SERVICE BULLETIN

REPUBLIC AVIATION CORPORATION
FARMINGDALE, LONG ISLAND, NEW YORK
SERVICE DEPARTMENT

SERVICE BULLETIN NO. 6

INSPECTION OF RIVETS – ELEVATOR CONTROL COLUMN

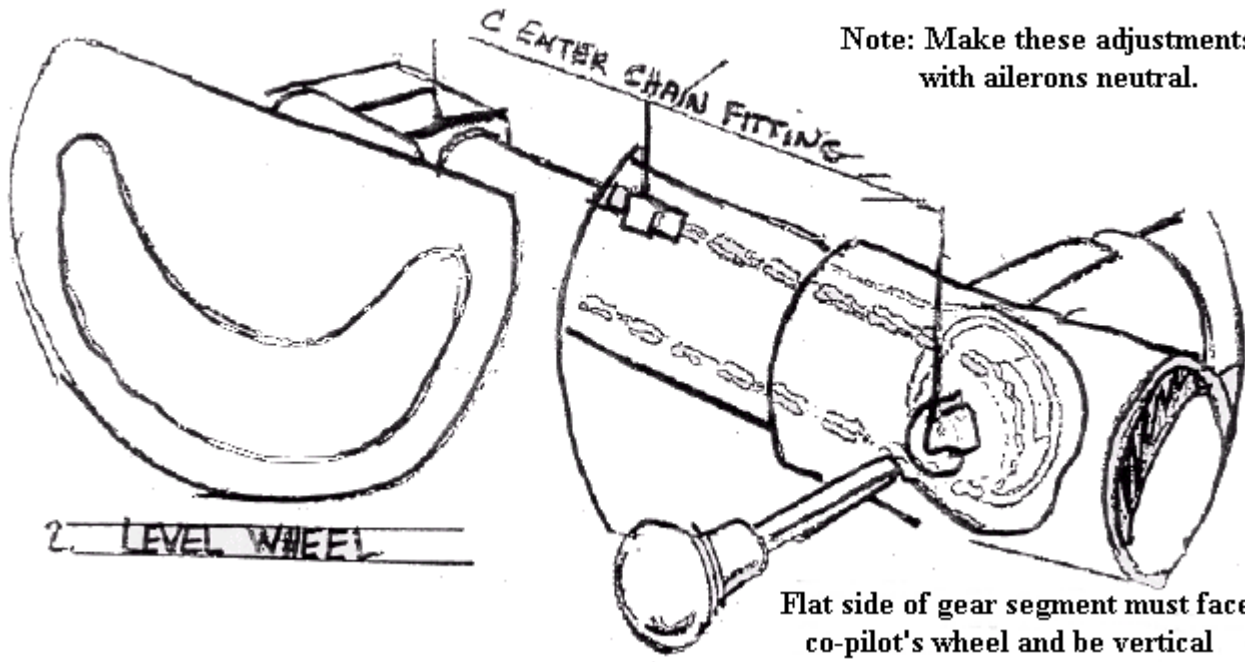
1. Remove torque tube shaft inside of push-pull tube by removing pin and sprocket on aft end of assembly and pulling torque tube shaft out forward end of tube.
2. Four (4) rivets holding the forked fitting on forward end of push-pull tube, if found to be 5/32", will be replaced with 6 (six) 3/16" rivets, AN456-AD6-6. If four (4) 3/16" rivets are already installed two (2) additional 3/16" rivets may be added (one on each side evenly spaced).
3. Check for satisfactorily formed riveted heads, then reassemble torque shaft and sprocket.

The rework calls for six 3/16” diameter rivets in place of the original four as an added safety precaution.
